SUBJECT: COMANCHE PEAK NUCLEAR POWER PLANT, UNITS 3 AND 4
DOCKET NUMBERS 52-034 AND 52-035
RESPONSE TO REQUEST FOR ADDITIONAL INFORMATION NO. 4579, 4606, 4608,
AND 4609

Luminant Generation Company LLC (Luminant) submits herein the response to Request for Additional Information (RAI) No. 4579, 4606, 4608, and 4609 for the Combined License Application for Comanche Peak Nuclear Power Plant Units 3 and 4. RAI No. 4579 involves emergency planning while the other RAIs involve meteorology questions.

Response to Request for Additional Information No. 4579 (CP RAI #159)

Response to Request for Additional Information No. 4606 (CP RAI #155)

Figure 1: Relative Humidity Instrument Location Perspective 1

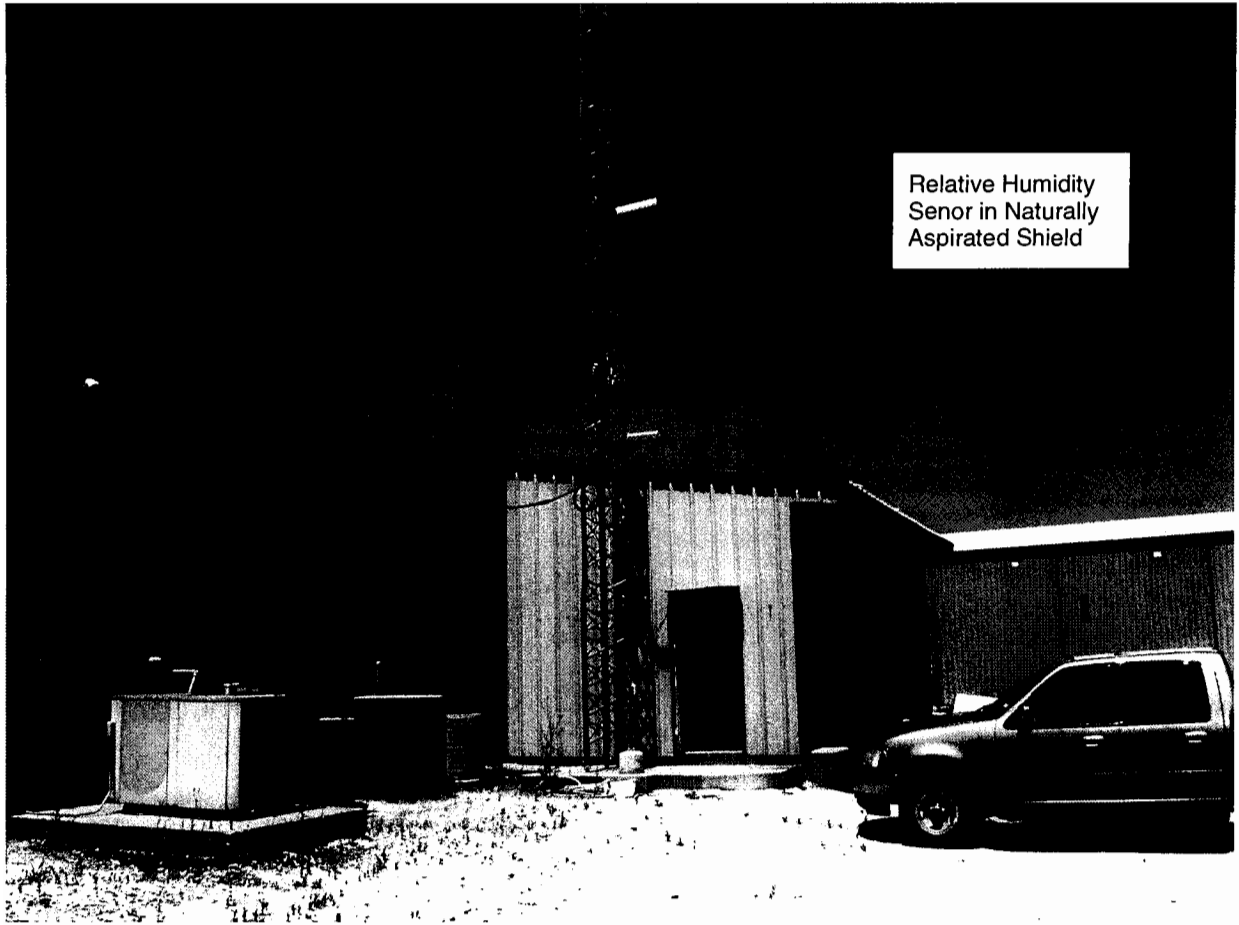
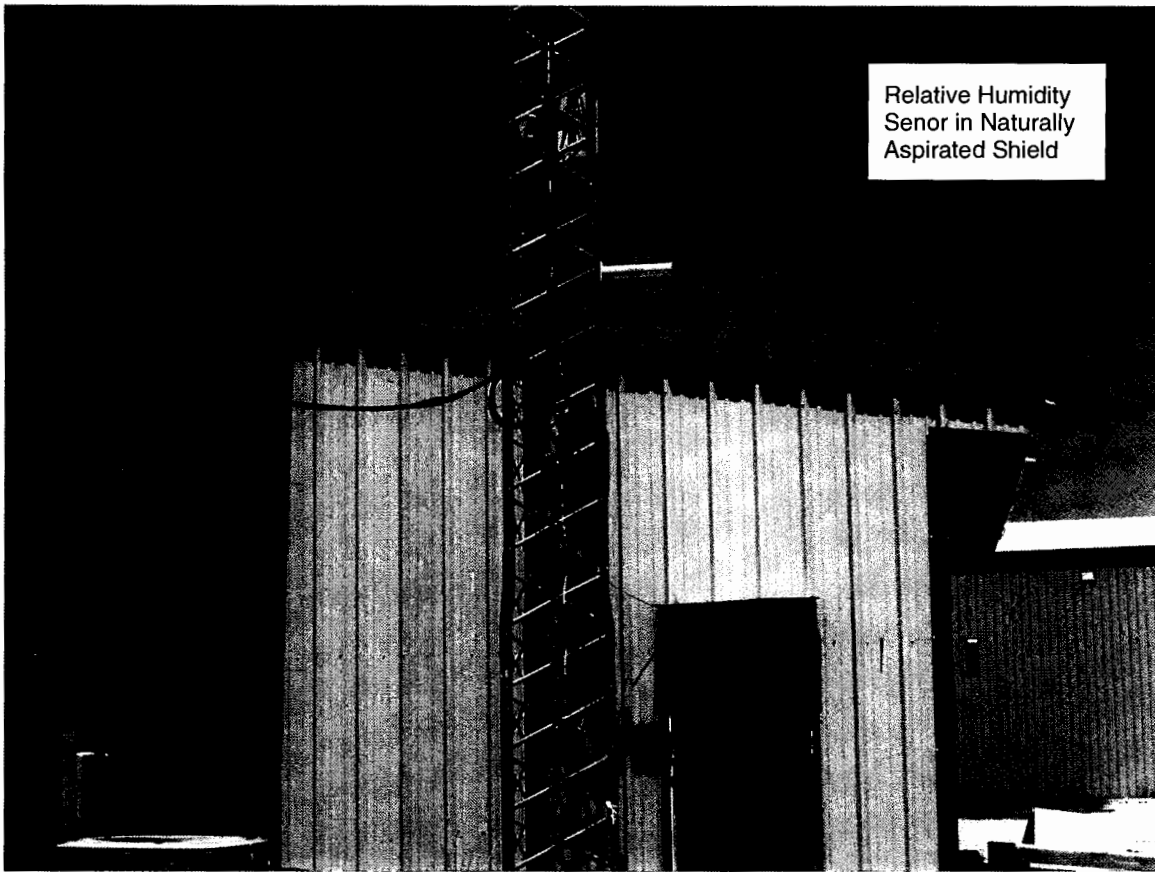
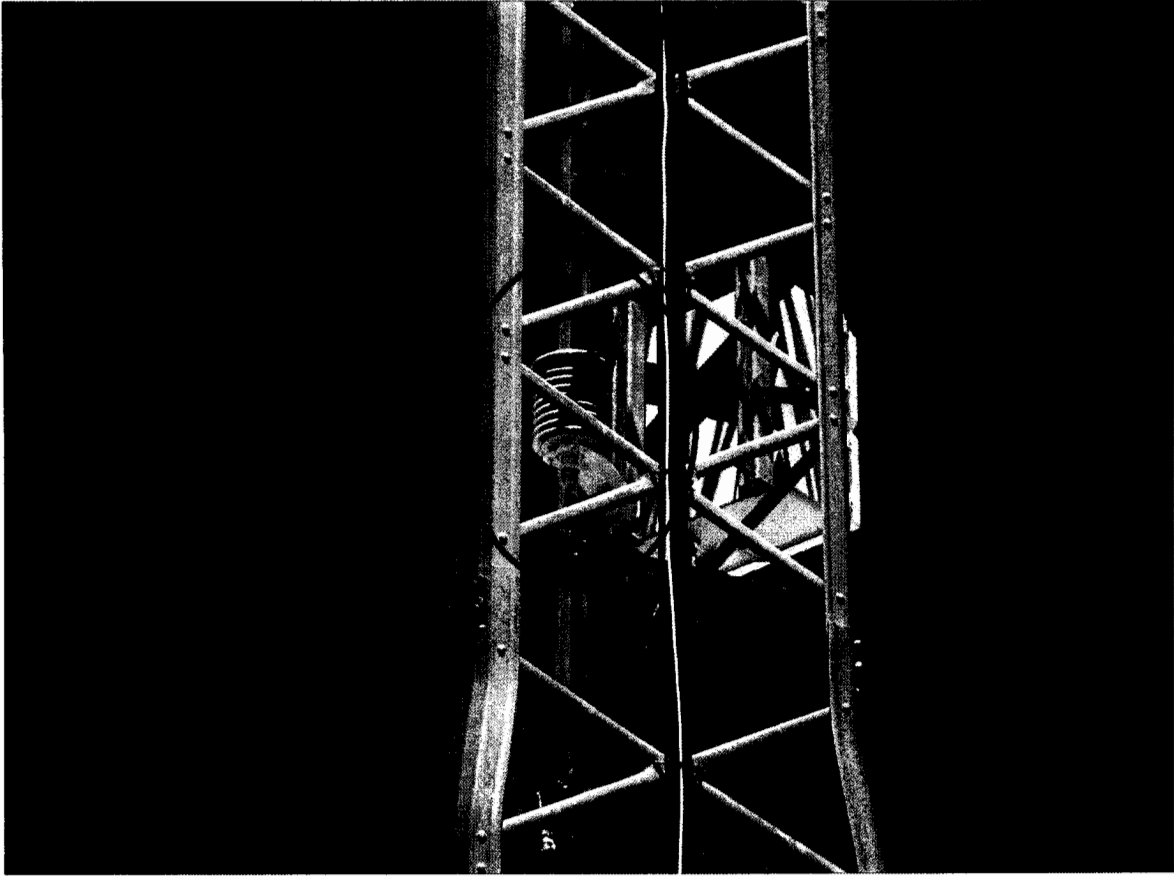
Further, the updated FSAR Section 2.3.3.1 states "the instrument was located on top of the Project Records Center Building". Please provide clarification that demonstrates the moisture data collected was obtained without interference from manmade objects and was not skewed because of the building's roof or surface materials.

the shield with maximum artificial radiation indicate that under conditions of low air movement (1 m/s) the temperature sensor is maintained within 2.7°F (1.5°C) of ambient. This improves to 0.7°F (0.4°C) or less at wind speed greater than 3 m/s. The location of the relative humidity sensor and the surrounding shield is depicted in the attached photographs (Figures 1 through 3). The photographs show that the instrument was sufficiently removed from manmade objects so that the data was not skewed because of the building's roof or surface materials.

Figure 2.3-383 Humidity Comparison - June 2008

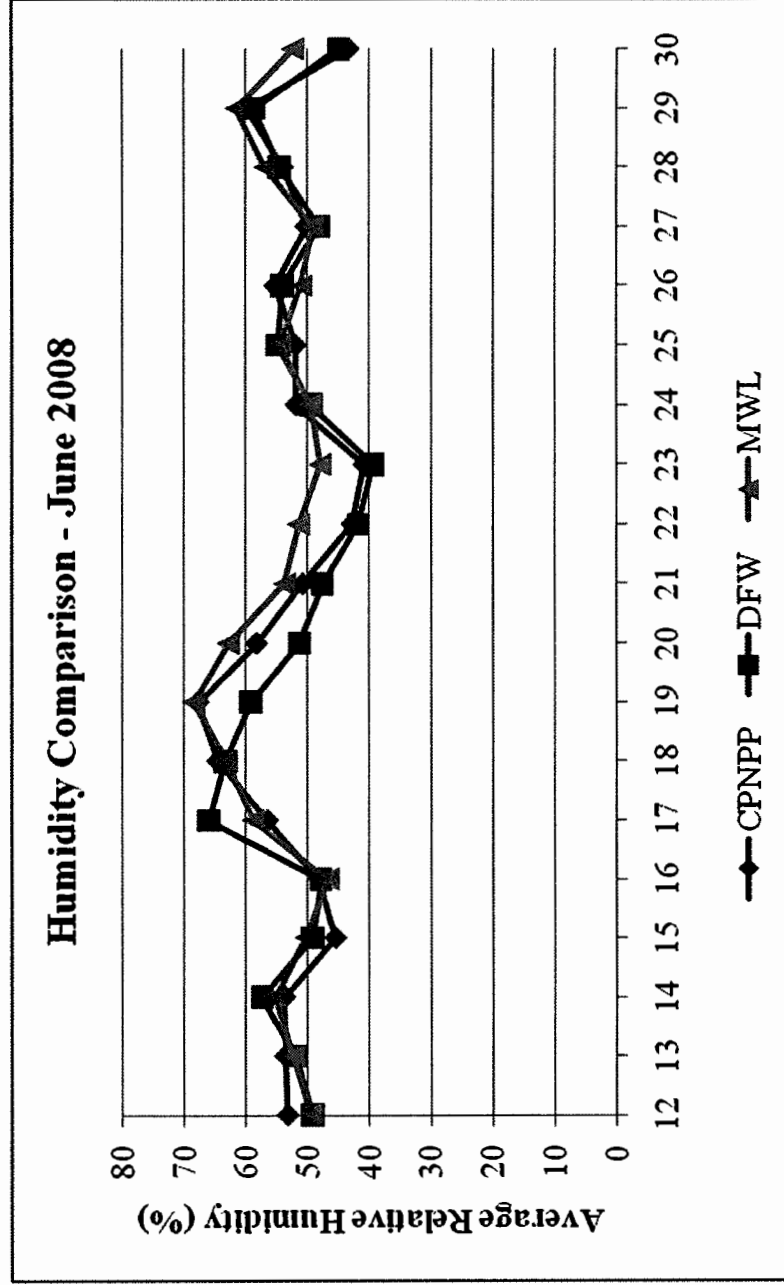
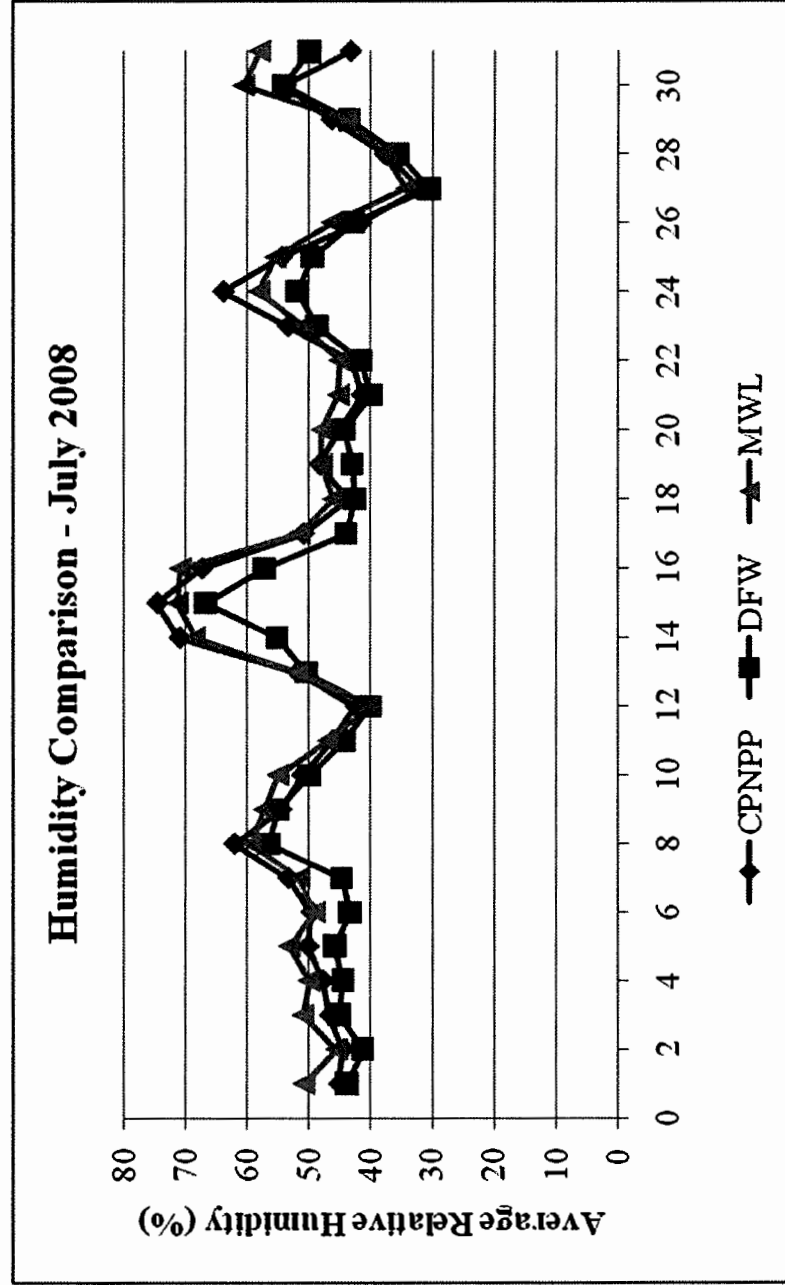
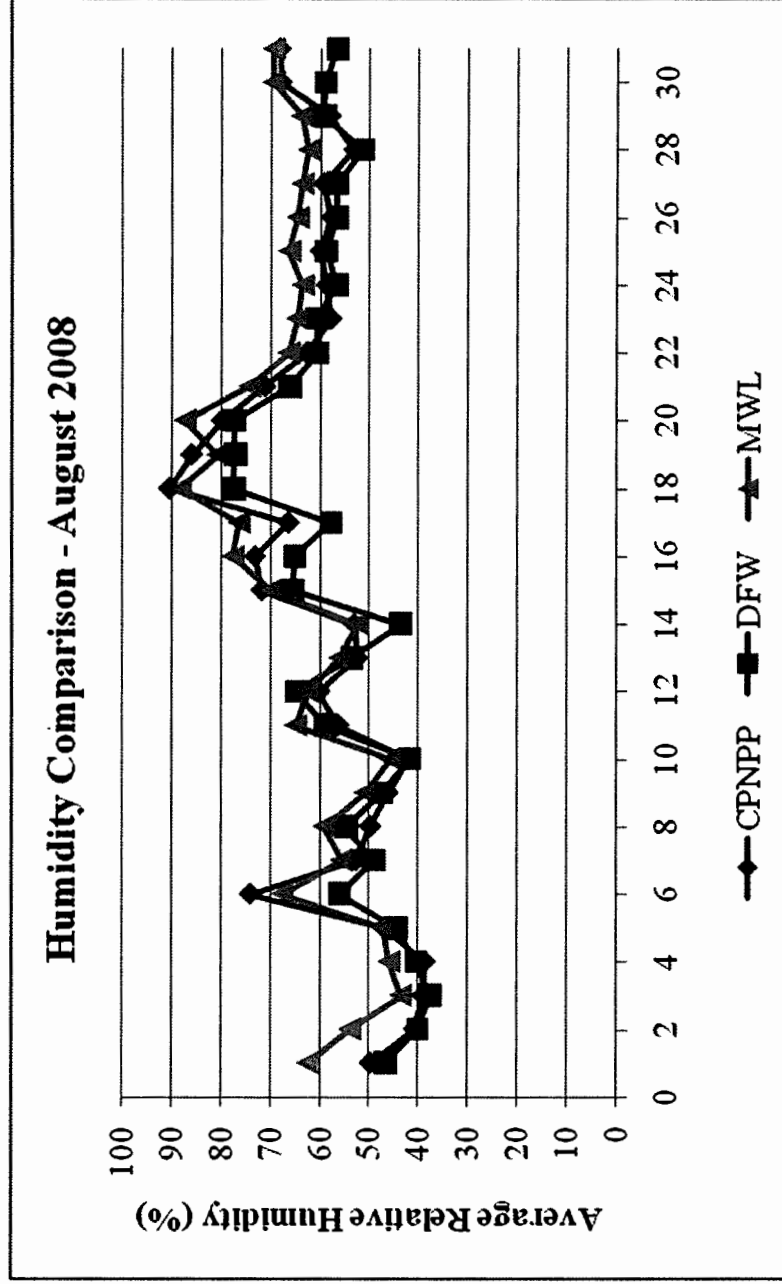
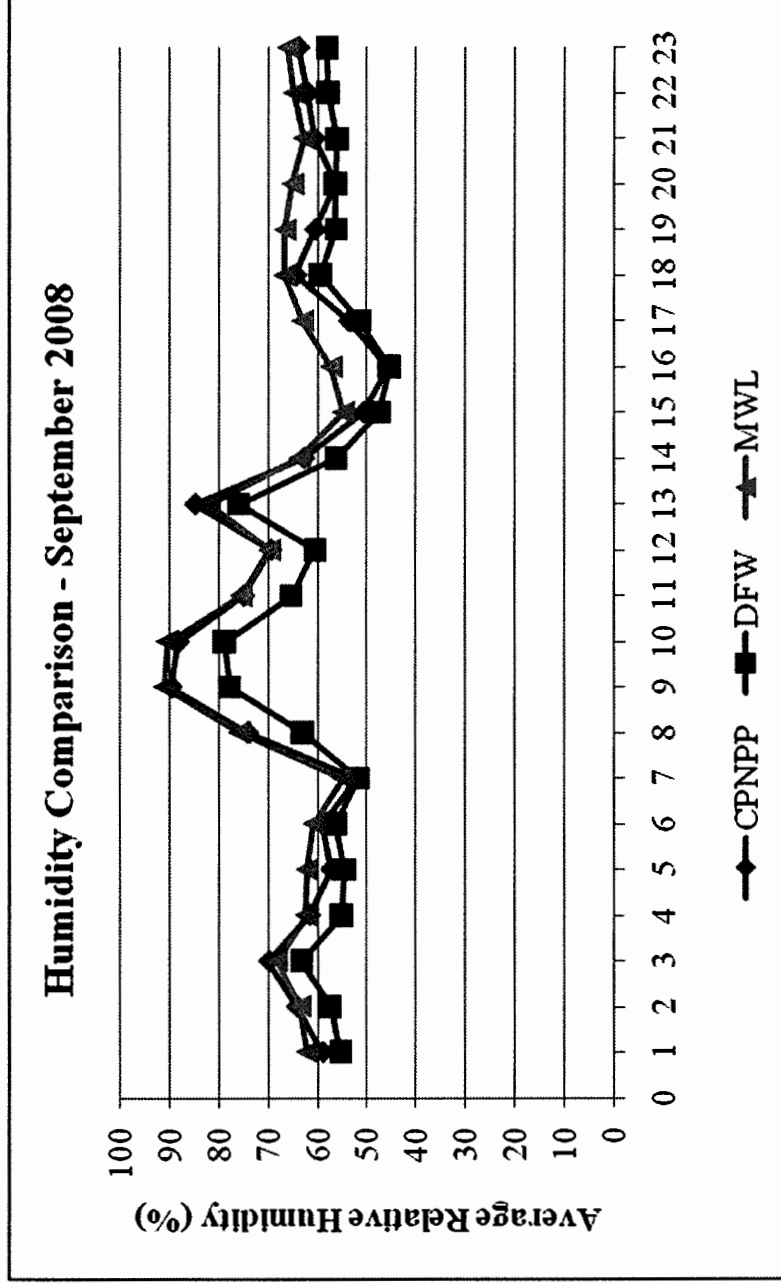
In response to RAI 2.3.3-3, Luminant provided information regarding the onsite moisture measurements collected from June 12, 2008 to September 23, 2008. The updated FSAR Section 2.3.3.1 states that "the pre-operational onsite data was used to demonstrate that the actual onsite conditions correlated well with longer term data from local weather stations which were used for the official calculations". The staff requests that the comparison of onsite data with first order weather stations be provided, along with the correlation demonstration of the data.

The comparison of the pre-operational onsite data with data from local weather stations has been added to FSAR Subsection 2.3.3.1.
